SKETCH D

OPTION 2A:

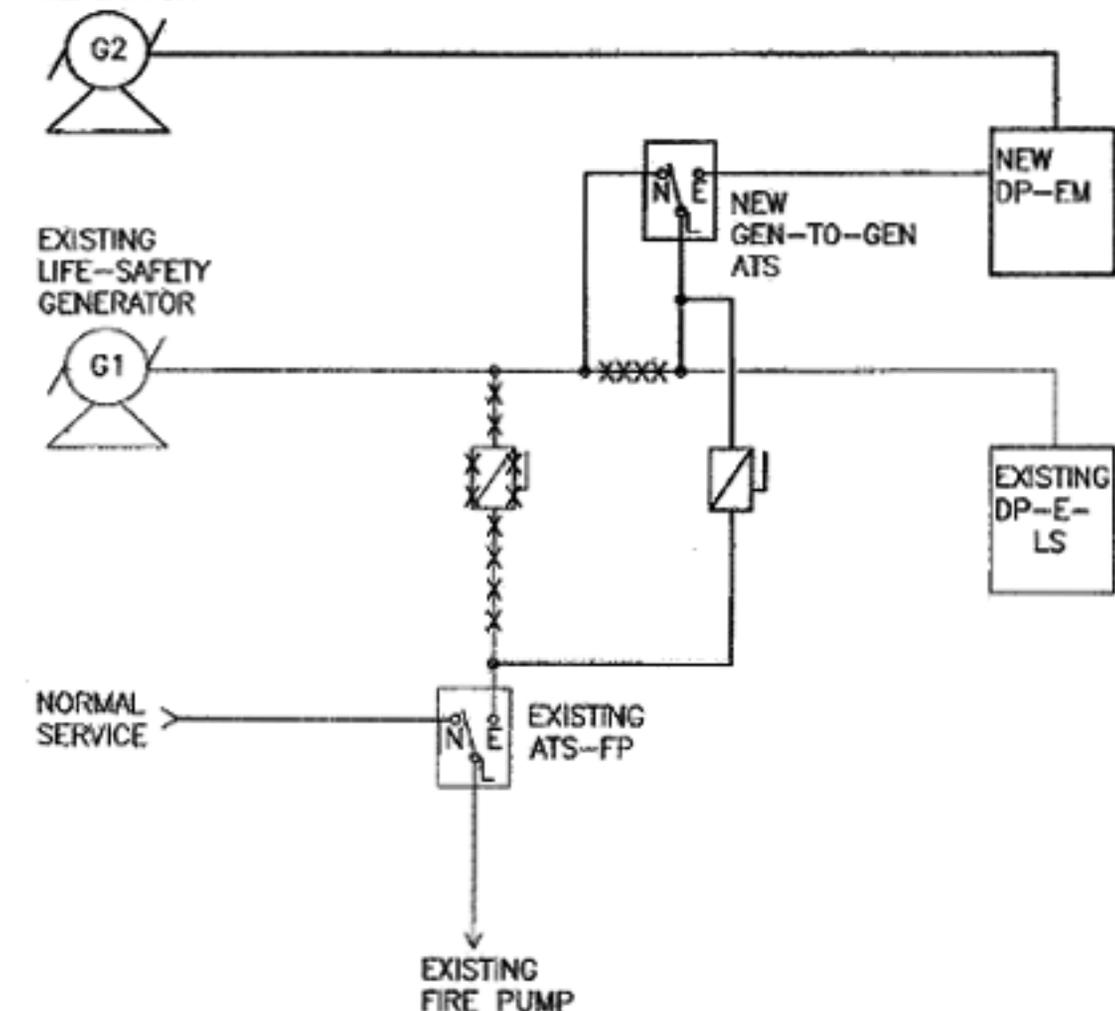
IN THE EVENT THE NEW VOLUNTARY GENERATOR 2 IS REQUIRED TO PROVIDE ADDITIONAL EMERGENCY POWER TO EXISTING FIRE PUMP, AND IN LIEU OF PROVIDING AN ADDITIONAL ATS AS INDICATED IN OPTION 2, A TAP MADE DOWN-STREAM OF THE GEN-TO-GEN ATS SHALL BE MADE TO PROVIDE EMERGENCY POWER TO THE EXISTING FIRE PUMP AS INDICATED ABOVE.
